Kirklees Local Plan

**Response to the Inspector's
Matters, Issues and Questions (MIQs)**

**Matter 2 – Spatial Development Strategy
with specific reference to
Land at Grimescar Road,
Birchcliffe – Site MX1904**

**Bradley Park Golf Course, Huddersfield
(Site References H351 and H1747)
Proposed Residential Allocation within Kirklees Site
Allocations Plan
Highway Documentation Review**

Image 2.2 Bradford Road Potential Access Extract

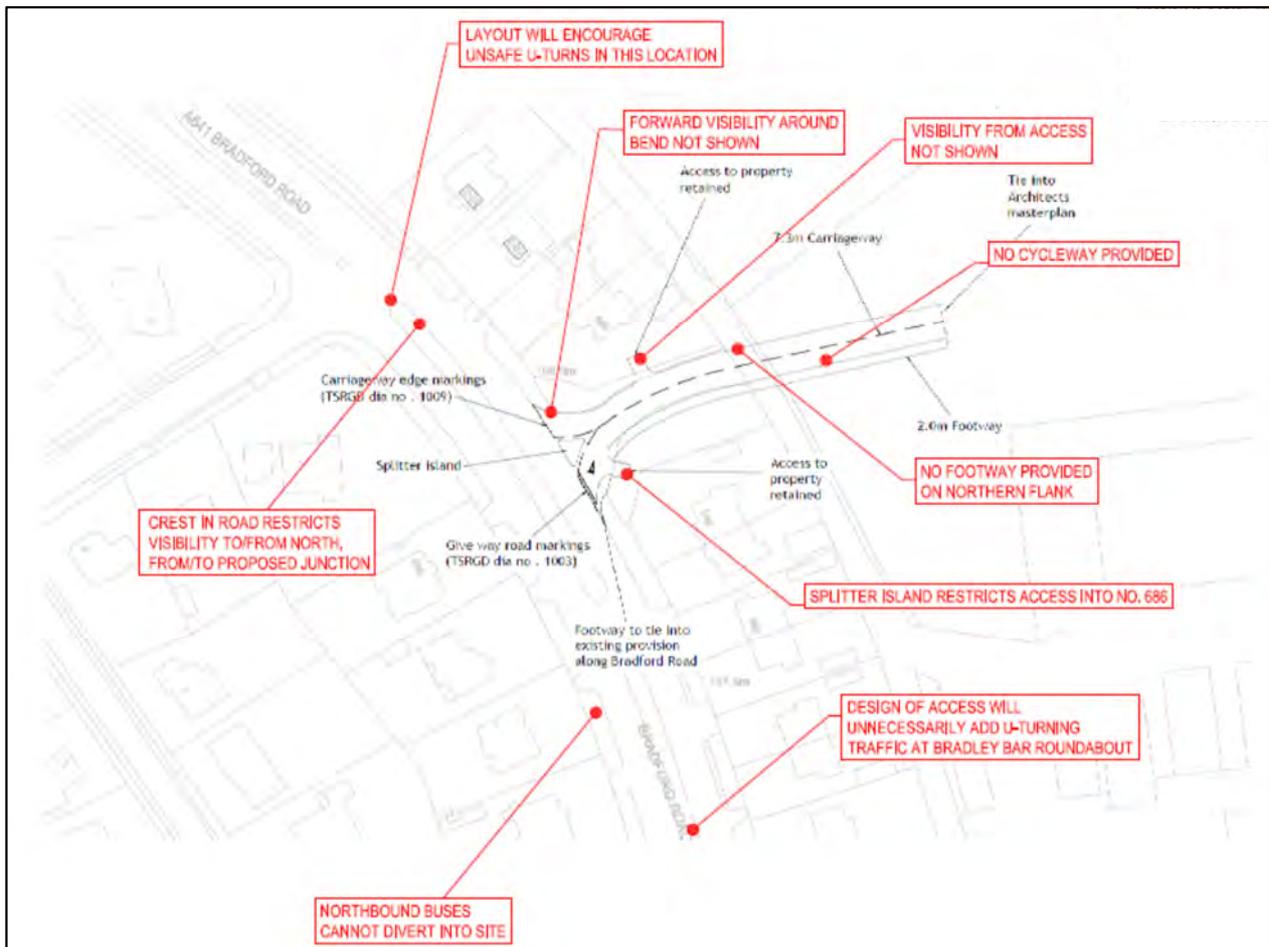
- Visibility for vehicles exiting the allocation is restricted by a crest in the road - a minimum visibility splay of 2.4m x 160m is required in accordance with DMRB for a 50mph speed limit. However as the 50mph zone is within close proximity to the Site access and high vehicle speeds have been observed in this location on a number of occasions, it is considered essential to justify the level of visibility by undertaking a vehicle speed survey and confirming that the splay is achievable in both the horizontal and vertical planes. A visibility splay of 2.4m x 160m does not appear to be achievable (see image 2.3 and 2.4) - Limited vertical visibility in this location would result in a highway safety issue;

- No right turn into or out of Site has been provided - This is likely to cause unsafe u-turning manoeuvres within the retained central reserve break for right turn into Dorchester Road. If the existing right turn facility is removed into Dorchester Road, this will add additional pressure onto the already congested Bradley Bar Roundabout by increasing the number of u-turning movements;
- Northbound buses on the A641 would be unable to route into the Site, contrary to the statement in Section 6.3 of the Fore Report (V1.0) which advocates buses diverting into the Site;

- A swept path analysis (attached in Appendix C) shows large vehicles would need to use both lanes to exit - which would reduce the capacity of the junction and could result in highway safety concerns;

- No capacity assessment provided to demonstrate that access has sufficient capacity both with and without flows associated with J24A which would be situated some 400m to the northwest of the access;

- Access to No. 686 Bradford Road is restricted by proposed splitter island which would mean that cars would have to enter the development and turn within the junction bell mouth, whilst caravans/vans would no longer be able to access the property;

- Visibility for vehicles exiting No. 688 is not shown and due to limited width and lack of footway provision, insufficient visibility can be achieved - forward visibility to vehicles entering the site is also not shown and could cause an issue given the generous radii and speed of Bradford Road;

- A Footway is only provided on the southern side of the junction; and
- No cycle provision shown.

2.2.2 The proposed access in this location would not be suitable due to the limited vertical visibility to the right (north) when exiting the Site causing a highway safety concern. The other issues highlighted further prevent any access in this location due to concerns over highway safety, capacity, bus penetration, substandard pedestrian and cycle provision and land ownership issues.

Image 2.5 Lamb Cote Road Potential Access Extract

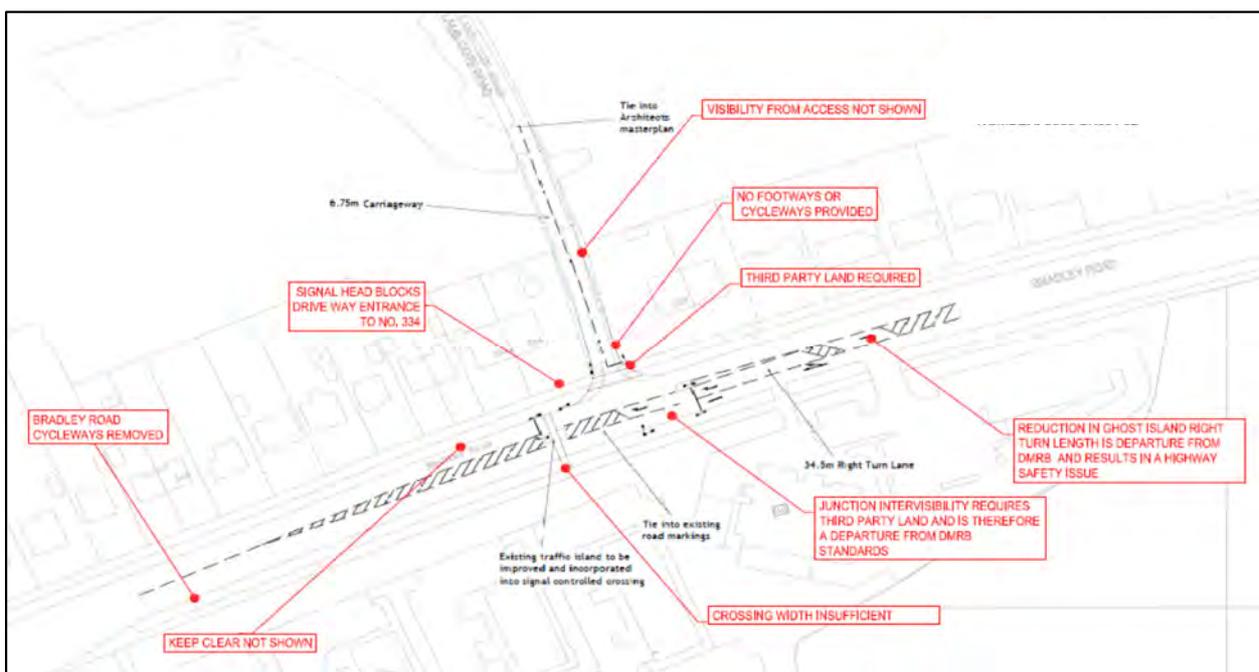
- The design shown requires third party land (No. 332 Bradley Road) and is therefore not deliverable and doesn't meet the third test of being an effective plan;

- The arrangement proposes to shorten the existing right turn lane into the public house/restaurant on the southern side of Bradley Road from 35m to 12m. DMRB recommends a minimum of 35m for the right turn lane and this should therefore not be shortened due to the potential for head on and rear shunt collisions given the proximity of the junction with Lamb Cote Road;

- The width of carriageway is not sufficient to accommodate the bus route for a development of over 400 dwellings;
- The required junction intervisibility at a signalised junction would require additional third party land;

- A swept path analysis in Appendix C shows large vehicles aren't able to left turn into the Site or left turn out of the Site and therefore the servicing requirements of the Site (shops, refuse, sports facilities) cannot be undertaken from this access;

- The capacity analysis shows that the junction is operating above the desirable capacity and would cause congestion on the network. Additionally, the basis of the capacity assessment hasn't been provided and it is considered that it underestimates the requirement as the size of the junction is significantly smaller than the adjacent Dyson Wood Way signalised junction which requires three lanes in a westbound direction and two exit lanes - an XY capacity analysis has been completed in the subsequent section which confirms that the access design is substandard;

- Access to No. 334 Bradley Road is restricted by the proposed signalised junction as the secondary signal head blocks driveway access whilst vehicles exiting No.334 would do so in the centre of the junction through a potential reversing manoeuvre due to inadequate room to turn within the plot;

- Visibility for vehicles exiting No. 332 Bradley Road is not shown and due to limited width and no footway, provision appears to be inadequate;
- No footways are shown and from the masterplan this appears to be the main access to the proposed shops, primary school and access to the existing secondary school. As designed pedestrians would be required to walk along the main spine road which results in significant and unacceptable highway safety concerns; and

- No new cycle provision shown which is considered essential to achieve satisfactory access to a development of this scale. Furthermore existing cycle lanes on Bradley Road are proposed to be removed as part of the access arrangements to the detriment of highway safety.

Image 2.6 Tithe House Way Potential Access Extract

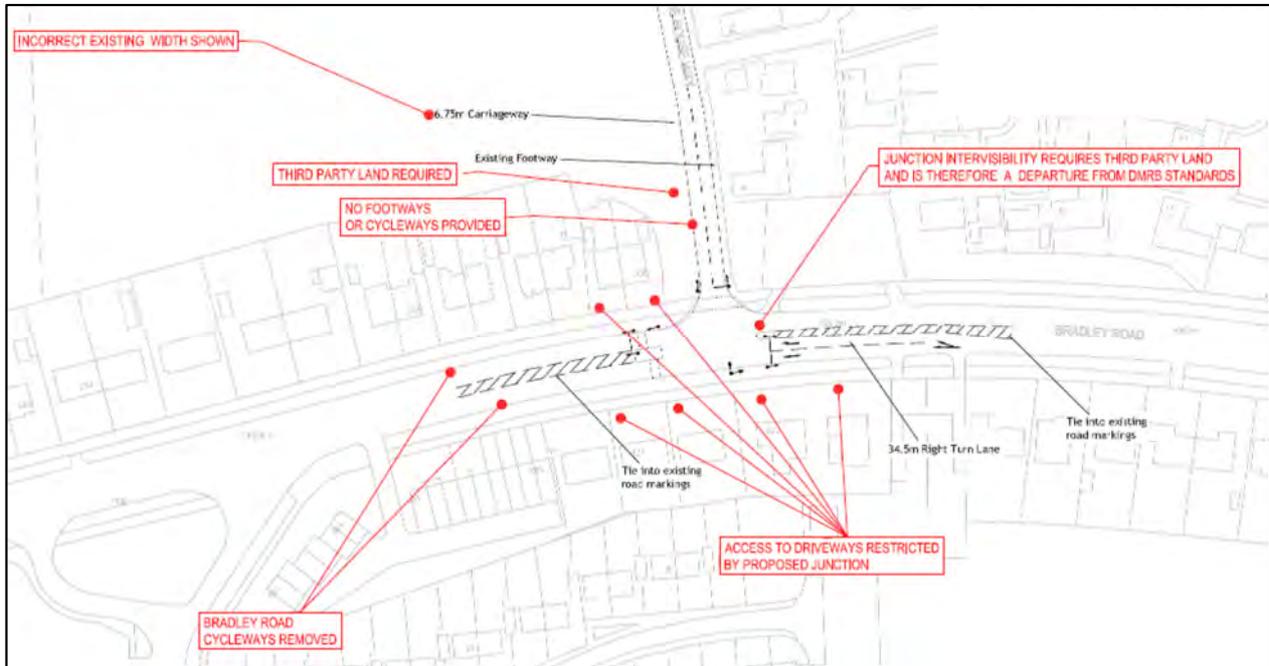
- The dimension of the carriageway on the Fore Consulting drawing confirms 6.75m, however the existing road is 6m wide and the area of land to the west is under third party control as such a width of 6.75m is not deliverable. The width of carriageway is not sufficient to accommodate the bus route for a development of over 400 dwellings;

- The signalised junction with a reduced width of 6m could be implemented without third party land, however two lanes are provided on Tithe House Way as indicated by the Fore Consulting report, therefore third party land would be required as shown on the plan in Appendix D (15117-IN-05). The modelling undertaken by Fore Consulting showed a maximum of 250 dwellings could be served from a single entry on Tithe House Way. Circa 122 are already served from this junction and therefore only an additional 128 dwellings could be served from the access arrangements proposed;

2.4.2 Given the constraints above, an appropriate access to serve this quantum of development in this location isn't achievable without third party land and the widening of the Bradley Lane Corridor to remove all the trees in the verge to allow for additional through lanes and the retention of the existing cycle lanes on Bradley Road.

Image 2.7 Cooper Bridge Draft Highway Scheme - Extract of Drawing 2 of Transport Model Technical Paper April 2017

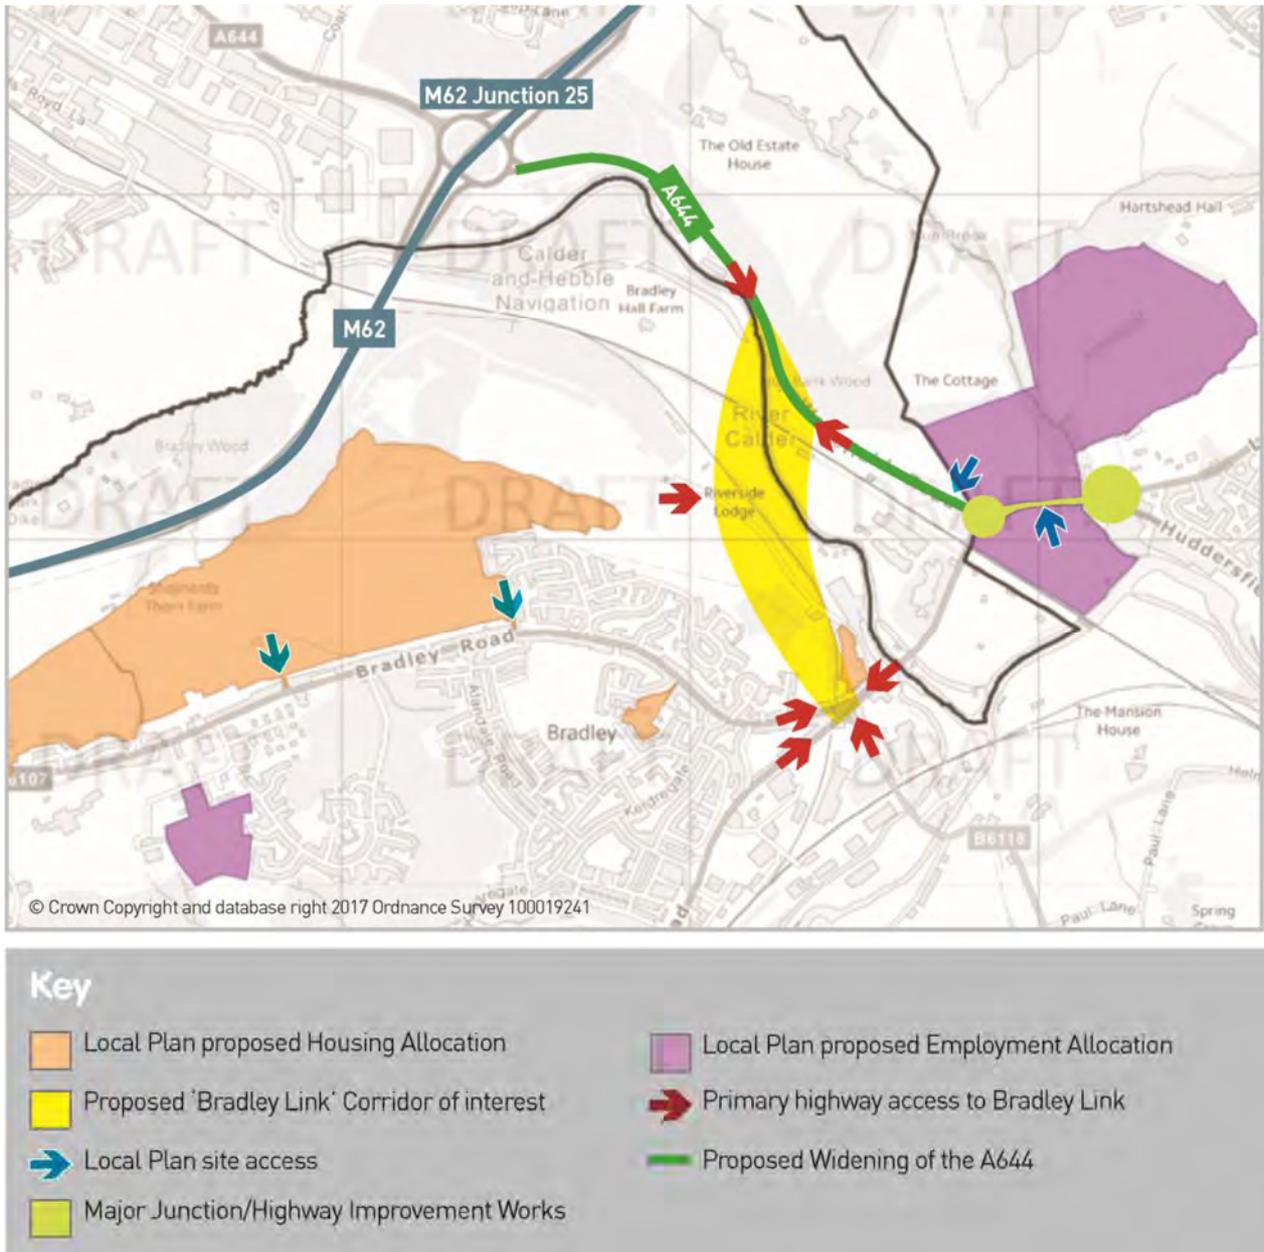
2.5.2 The indicative alignment of the link road is shown in Image 2.5, which shows a significant gap between the Site and link road study area and therefore it is not known whether this missing link could be deliverable or whether there would be a further third party land constraint.

3.3.2 As the exact scheme at Cooper Bridge is still undergoing feasibility studies, the Bradley Link as shown in Drawing 2 of the Kirklees Council Transport Model Technical Paper may not be delivered subject to design and relevant economic viability case. It is considered that this option has the following difficulties to delivery which may affect the economic case:

- Network Rail - The alignment shown in the transport model (Drawing 2) requires the crossing of three existing rail lines;
- River Calder and Hebble - The alignment shown requires the additional crossing of the River Calder in close proximity to the railway line;

3.3.3 Due to the above, there is no certainty of the Bradley Link being delivered or at least within the plan period.

1. COMMENTS PROVIDED ON FORE CONSULTING DRAWING NUMBER: 3363 SK001 01

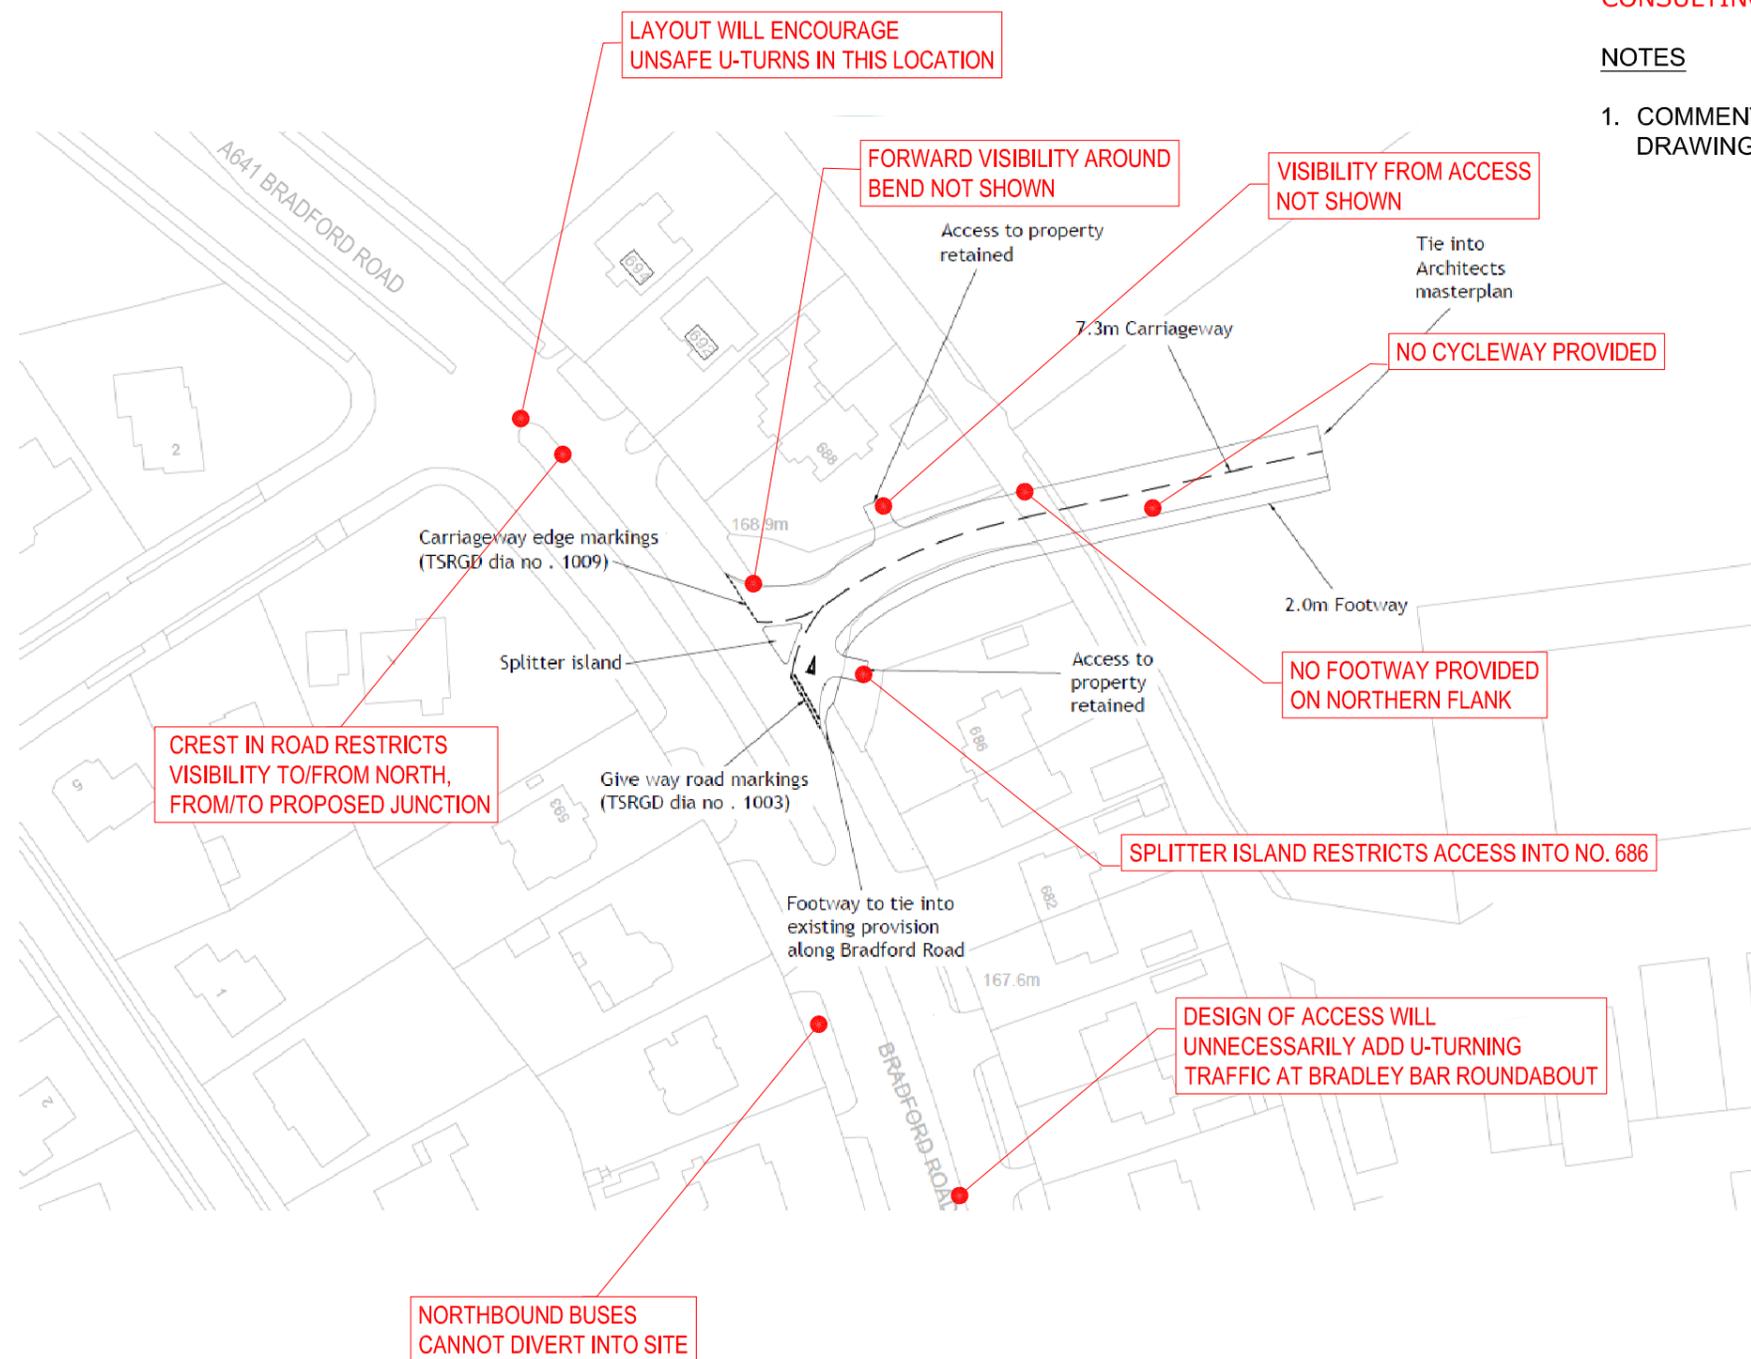
OPTIMA HIGHWAYS COMMENTS ON FORE CONSULTING DRAWING
